EXECUTIVE SUMMARY
INSPECTION REPORT 50-220/88-201
NINE MILE POINT UNIT 1

U.S. NUCLEAR REGULATORY COMMISSION
OFFICE OF NUCLEAR REACTOR REGULATION

Docket No.: 50-220

FIGURE 1

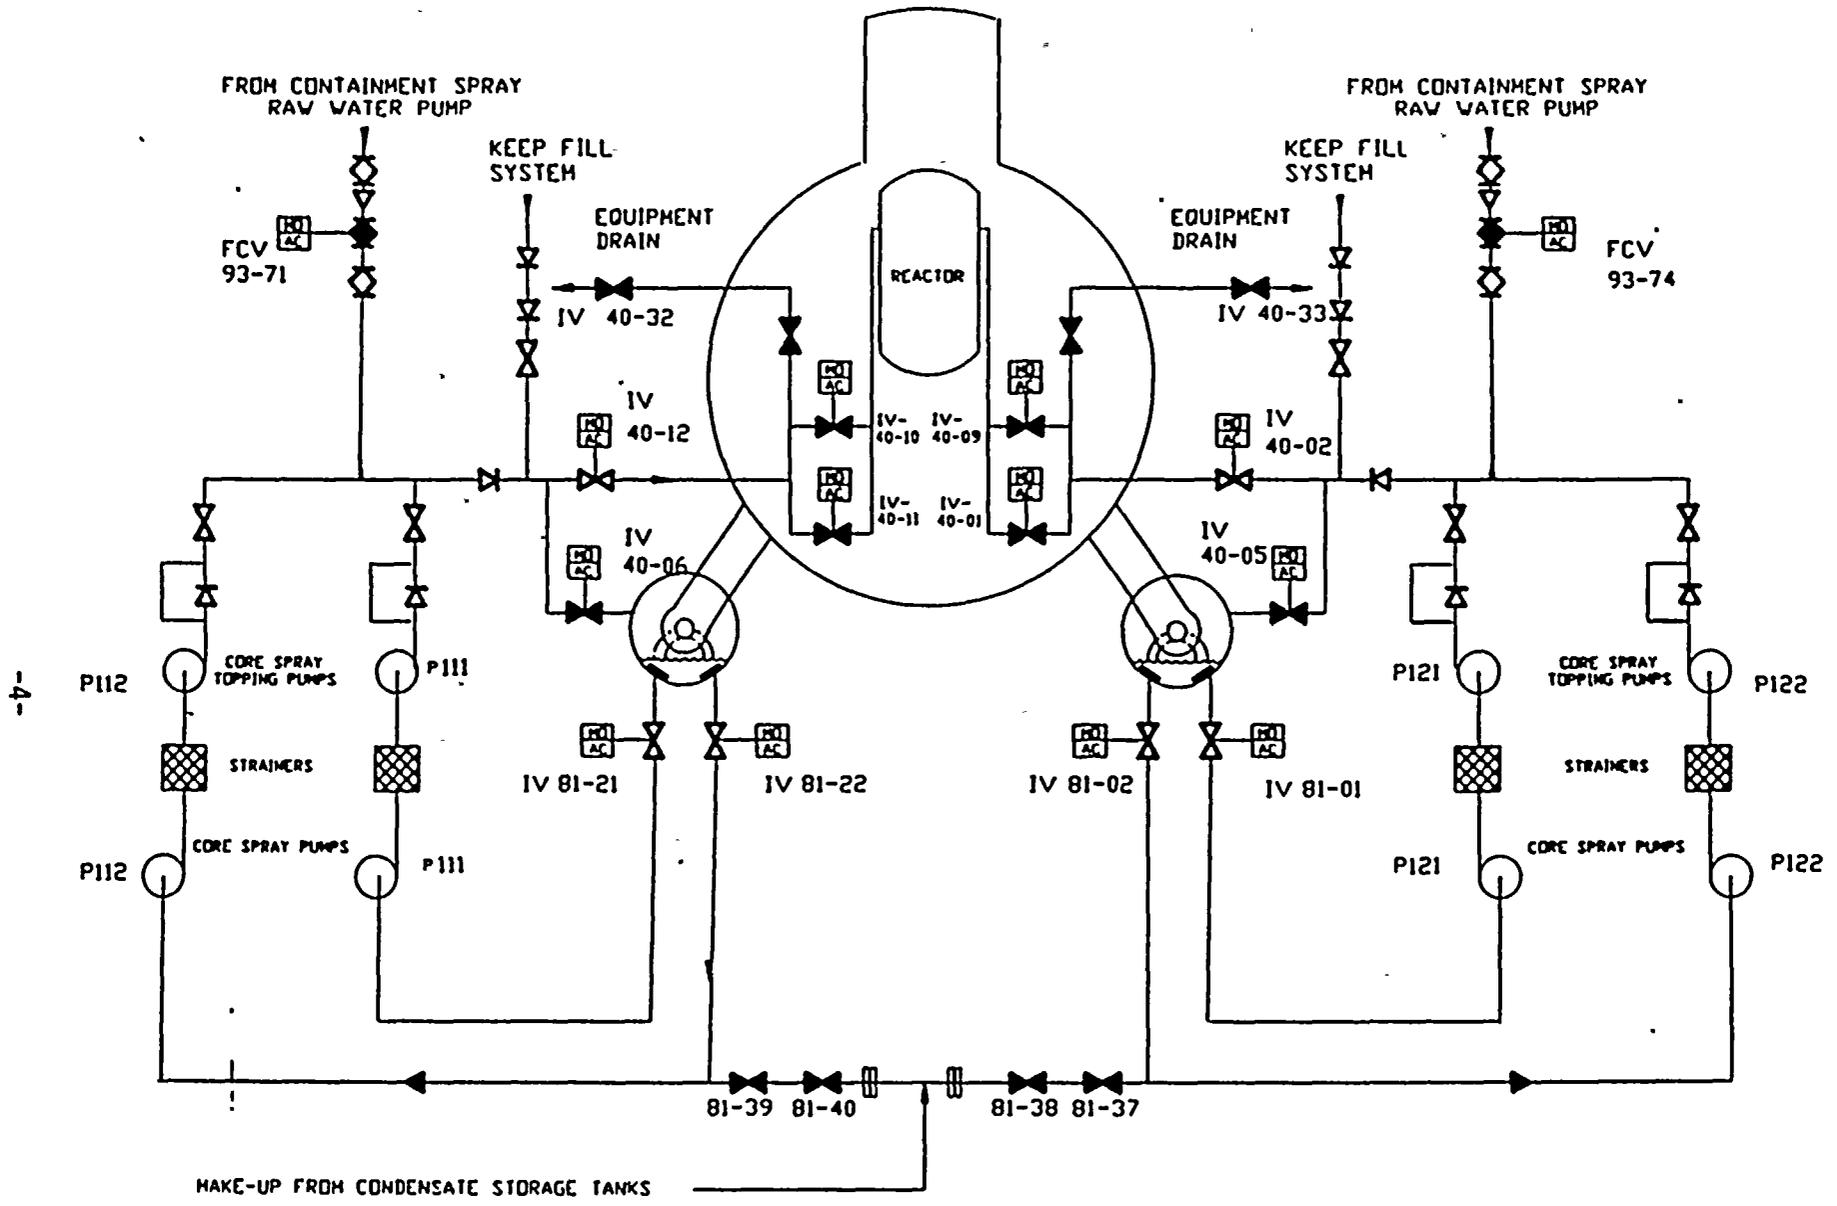
The inspection team reviewed the analyses supporting the assertions made in the FSAR, Technical Specifications and safety analyses about core spray system performance and identified the following concerns:

- (1) The system resistance curves did not account for the resistances associated with the piping from the torus to the discharge of the topping pumps, system flow orifice, pump suction grating, system strainer and one check valve. Collectively, these additional resistances could significantly increase the resistance coefficient for the system curves.

- (3) The text in Section VII of the FSAR stated that each set of pumps was capable of providing 3400 gpm to the spray nozzles at 299 psig, but this point appeared to be above FSAR Figure VII-2, "Core Spray Pump Characteristics." The curve shown in Figure VII-2 was used for determining acceptable pump performance during surveillance testing.
